Program Bulletin

SUBJECT: Air Conditioning System Inoperative or Cools Intermittently

MODELS: 2013-2014 Chevrolet Spark

Subject: 13434B – Customer Satisfaction Program
Air Conditioning System Inoperative or Cools Intermittently
Revised Service Procedure

3828227

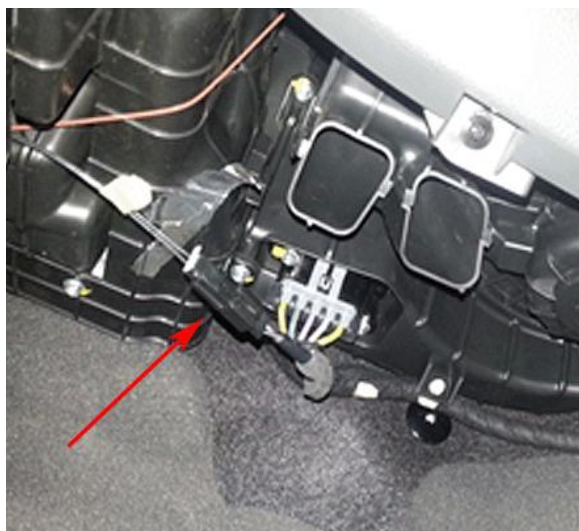
The switch installation procedure has been revised. A Caution statement has been added before Step 2, a revised illustration for Step 18 has been added, and Steps 26 & 27 have been revised. Please discard all copies of bulletin 13434A.

18. Connect the connector to the Low Pressure Switch and attach the new harness with C-clips to the A/C pipe.
